Request from Silver Oak Enterprises, LLC (owner) represented by Jeffrey Grubb (officer), for review and approval of "Carman Estates Plat 6" preliminary subdivision plat, located at 5800 SE 24th Street.				<b>File #</b> 10-2001-1.08-5	
<b>Description of Action</b>	Review and approval of the subject subdivision plat to allow for division of 12.6 acres of subject property into 76 lots for ranch row townhome units, and a common lot for the surrounding land serving the development.				
<b>2020 Community Character Plan</b>	Low/Medium Density Residential.				
<b>Horizon 2025 Transportation Plan</b>	Indianola Avenue from SE 14 <sup>th</sup> Street to Army Post Road to widen from 2-lane undivided to 4-lane undivided.				
<b>Current Zoning District</b>	"PUD" Planned Unit Development District.				
<b>Proposed Zoning District</b>	N/A.				
<b>Consent Card Responses</b>	In Favor	Not In Favor	Undetermined	% Opposition

Carman Estates Plat 6 -Preliminary Plat - SE Payton Ave & Indianola Ave 10-2001-1.08-5

**APPROVAL** of a request from Silver Oak Enterprises, LLC (owner) represented by Jeffrey Grubb (officer), for approval of a preliminary subdivision plat for "Carman Estates Plat 6" located at 5

**CARMAN ESTATES PLAT 6**  
 DATE: 02/27/07  
 SCALE: 1"=40'  
 NORTH  
 CIVIL ENGINEERING CONSULTANTS, INC.  
 2400 80TH STREET, UNIT 12, DES MOINES, IOWA 50322-8179  
 PHONE: 515.276.4884 FAX: 515.276.7084  
 SHEET 4 OF 4

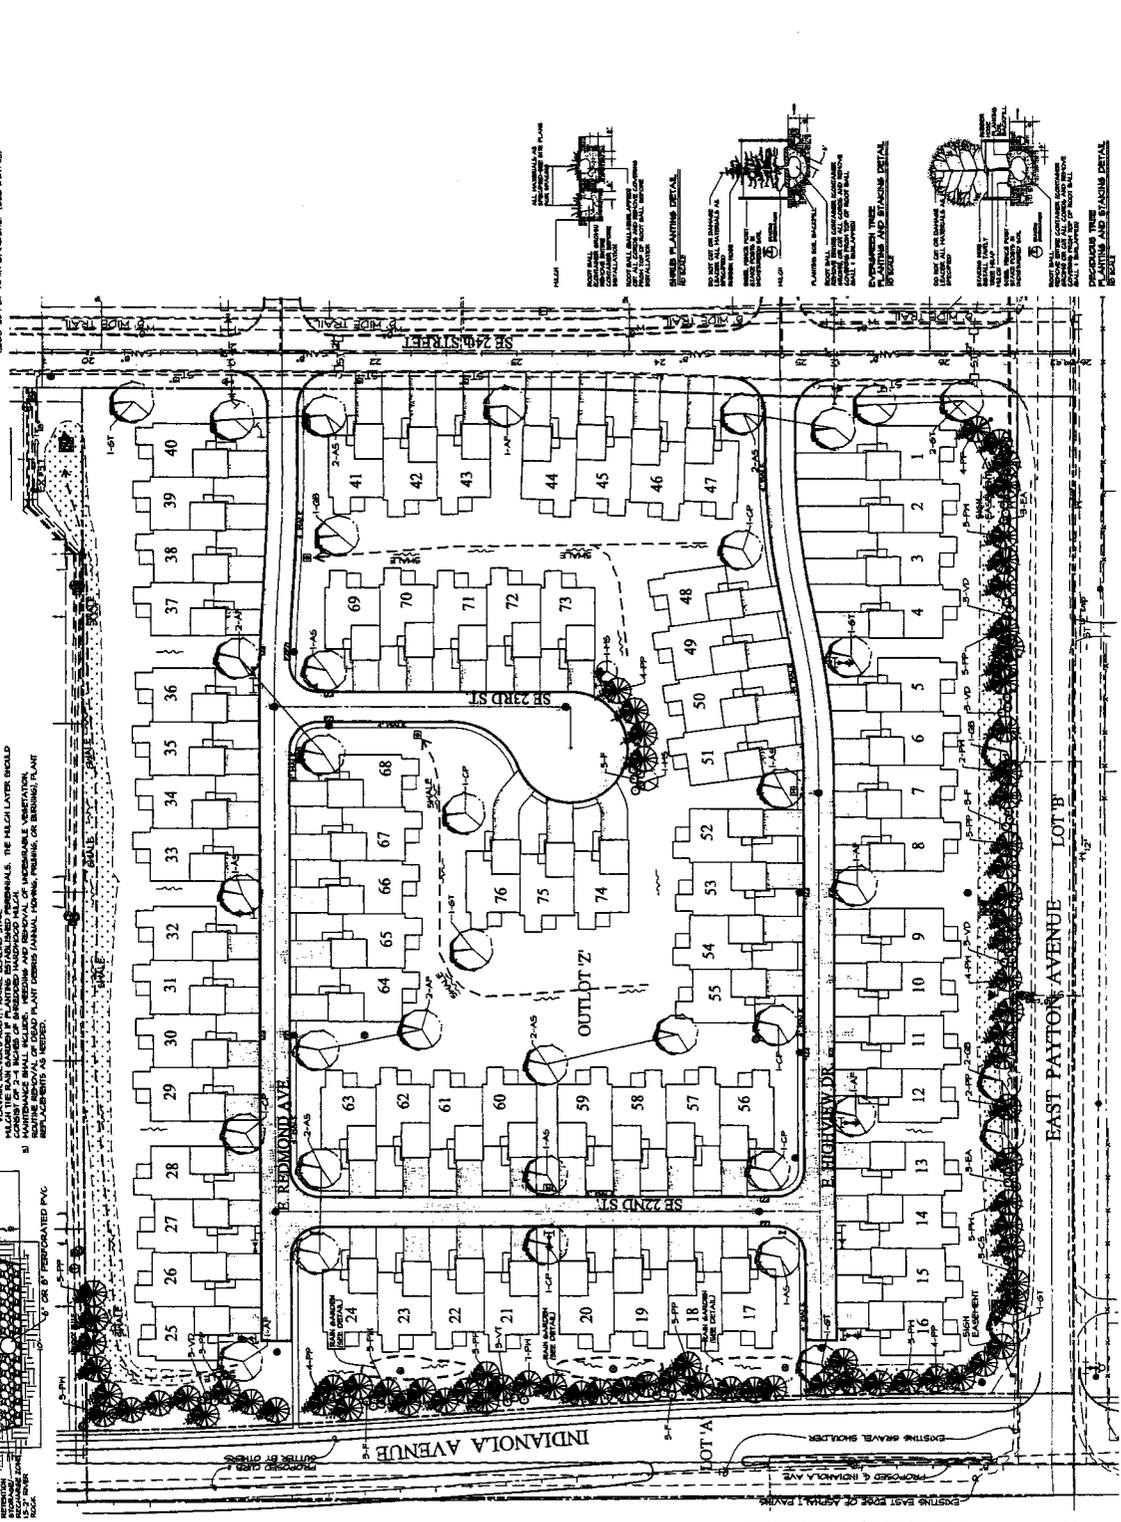
removal for building locations. This is consistent with language in the approved Conceptual Plan. The recent Conceptual Plan amendment was approved with a condition requiring submittal of a tree survey and mitigation plan as part of any preliminary plat or multiple-family development plan. The submitted preliminary plat anticipates removal of the trees along the south fence line as a result of the proposed storm water management for the site. Staff has determined that 84" of the trees to be removed would be considered a species under those permitted by the Des Moines' Landscape Standards. Staff recommends that the developer plant 84" inches of overstory, evergreen, or ornamental trees to mitigate those of a desirable species being removed. This amounts to 42 tree plantings over the minimum required under the open space. The applicant has responded to this by adding 42 additional evergreen tree plantings. Also the proposed overstory tree plantings have been relocated to frame the private drive system in the same manner as street trees on a public street.

2. **Drainage/Grading:** As part of the Conceptual Plan amendment approval, the City Council required an evaluation of conservation or low impact methods as part of storm water management design. The developer has revised the storm water management plan to incorporate rain garden features to handle portions of the events more frequent than the five-year storm.
